REMARKS

Proposed REPLACEMENT SHEET

Appendix to Drawing Amendment
 Annotated Sheet Showing Changes
 and explaining view as discussed
 in Remarks.

Fig. 5

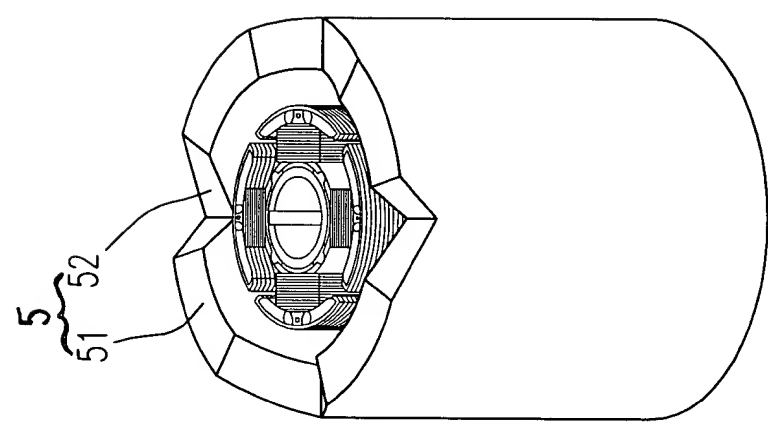
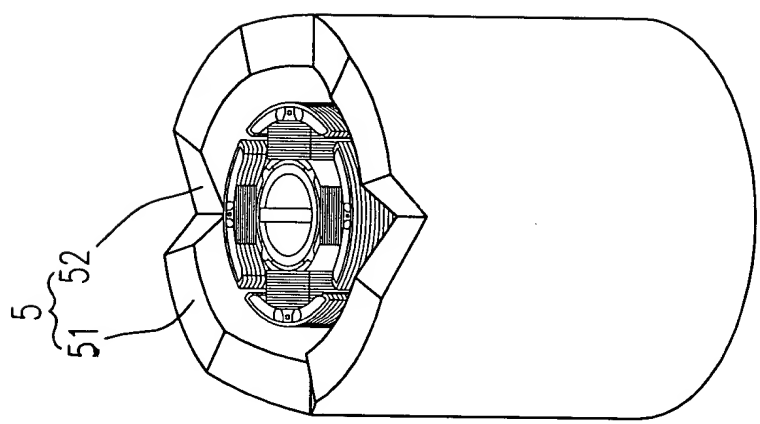
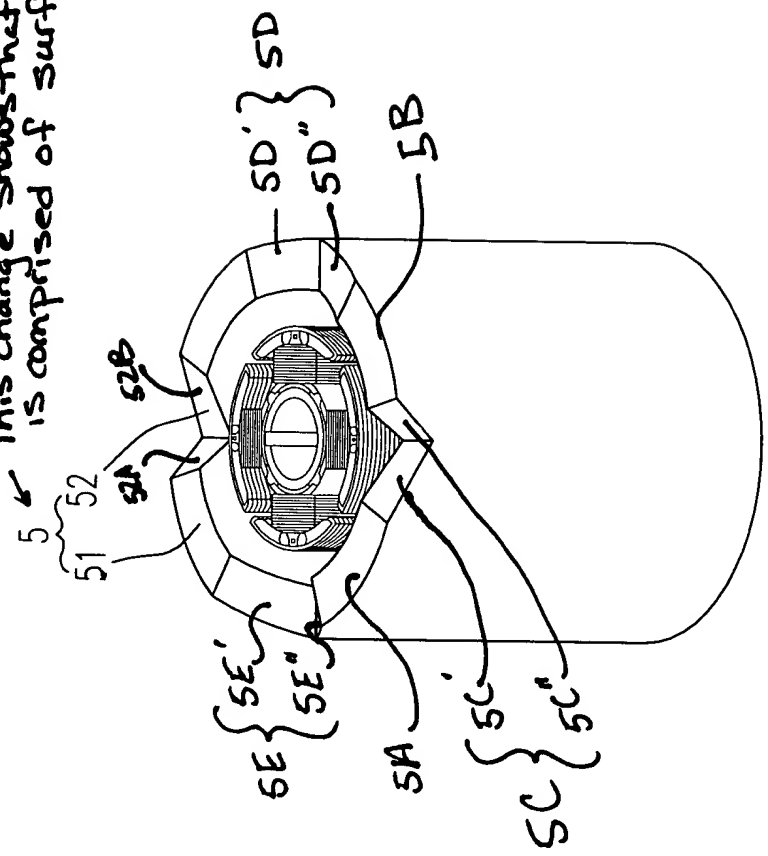
Please amend Fig. 5 as shown on the enclosed drawing with the proposed changes marked in red. A substitute drawing sheet showing the amended Fig. 5 is enclosed herewith.

Claims 9 and 11 are rejected under 35 U.S.C. §112, first paragraph, as containing subject matter which was not described in the specification and drawings. Regarding claims 9 and 11, the Office Action states that the drawings and the specification fail to disclose the rotor and stator cylinder having an irregular lumpy edge comprising a plurality of concave surfaces and convex portions.

To address the Examiner's concern, applicants have amended the specification to recite an irregular lumpy edge 5 as stated in claims 9 and 11 as originally filed, and have further amended reference number 5 in Fig. 5 to show that the lumpy edge comprises the concave and convex surfaces, 51 and 52, as stated on page 5, lines 15-16 of the specification as filed, i.e., "a lumpy edge which is a combination of a plurality of concave surfaces 52 and a plurality of convex surfaces 51." The reference number 5 in amended Fig. 5 clearly shows that it refers to both reference numbers 51 and 52. For purposes of illustrating the irregularity of the edge 5 in Fig. 5 as filed, applicants also submit a copy of Fig. 5 as originally filed, marked to show features illustrating the irregularity of the edge. Note in the portion numbered 5A, the outer edge forms a curve having a different arc than the outer curve of the section marked 5B. Note also that the section marked 52 has two faces, 52A and 52B which are of different surface areas and that both slant down and inwardly towards the inside surface of the rotor. The opposite section, marked 5C in the enclosed copy of Fig. 5, is also comprised of two faces 5C' and 5C", one having a larger surface area (5C') than the other (5C") and both sloping down, but outwardly towards the outer side of the rotor. Surface 51 as the specification states is convex, curving upwards. The section denoted by

number 5D has two faces, 5D' and 5D" that appear to be roughly equal in surface area. The opposite section, marked as number 5E also has two faces, 5E' and 5E", but they are not equal in surface area. Section 5E' is clearly shown to be larger in surface area than section 5E". The foregoing detailed analysis of Fig. 5 demonstrates that the Figure clearly illustrated from the time the application was filed, that the edge 5 is lumpy and irregular. Thus, the introduction of the term "irregular" in the claims is not new matter. The irregularity of the lumpy edge has been part of the application from the time of filing and was clearly in the possession of the applicants at that time. Moreover, the claims form part of the specification, so the fact that the original claims included this feature is further evidence that applicants had possession of this aspect of the invention at the time of filing the application.

5 ← This change shows that the lumpy edge 5
 is comprised of surfaces 51 and 52.

Referring to Fig. 5, the third preferred embodiment of the present invention provides a structure for magnetizing a rotor magnet. The structure in Fig. 5 is the same as that in Fig. 2, except that the rotor has a magnet cylinder with a an irregular lumpy edge 5 which is a combination of a plurality of concave surfaces 52 and a plurality of convex surfaces 51 ~~arranged in an arbitrary (or random) sequence~~. Certainly, a structure for magnetizing a stator magnet is also suitable, wherein the stator has a magnet cylinder with a lumpy edge 6 shown in Fig. 6 which is a combination of a plurality of concave surfaces 62 and a plurality of convex surfaces 61~~arranged in an arbitrary (or random) sequence~~.

With the amendment to Fig. 5, the feature of the rotor having a magnet cylinder with an irregular lumpy edge is now more clearly discernable in the drawing and in the specification. Therefore, the amended specification and revised Fig. 5 provide support for the claimed feature. Reconsideration and withdrawal of the §112 rejections of Claims 9 and 11 are respectfully requested.

Fig. 6

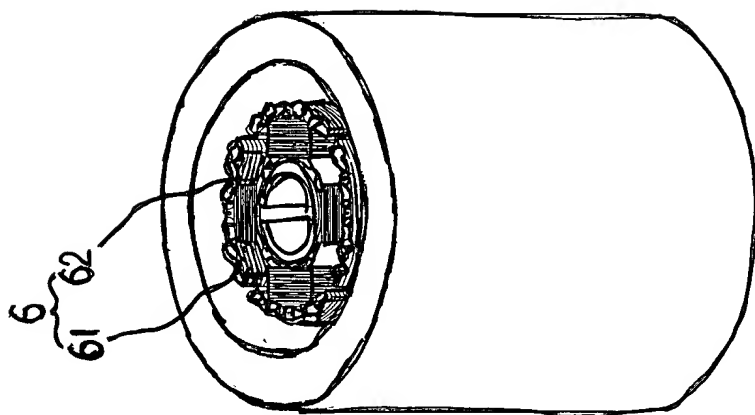
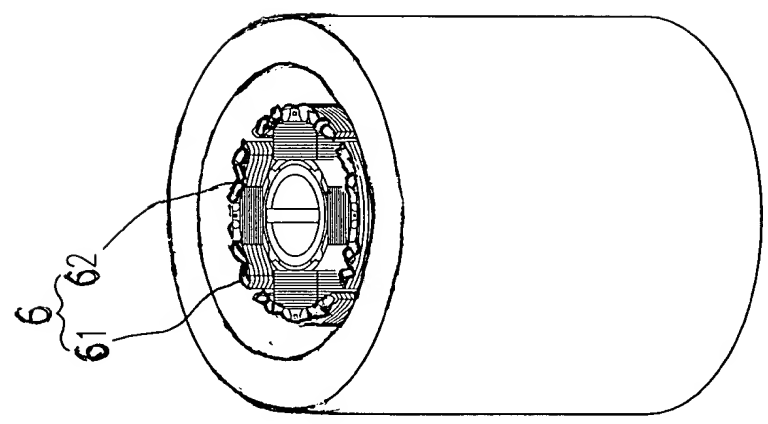
Please add new Fig. 6 as shown on the enclosed drawing sheet. A proposed Fig. 6, shown in red, is enclosed as well as a back and white version of Fig. 6.

New Fig. 6 is submitted herewith to illustrate the subject matter of claim 11. Basis for the structure shown in Fig. 6 can be found in the specification at page 3, lines 19-24 and at page 5, lines 16-19 describing a "stator magnet ... wherein the stator has a magnet cylinder with a lumpy edge which is a combination of a plurality of concave surfaces and a plurality of convex surfaces." Thus, no new matter is introduced by the amendment to the specification or the addition of Fig. 6.
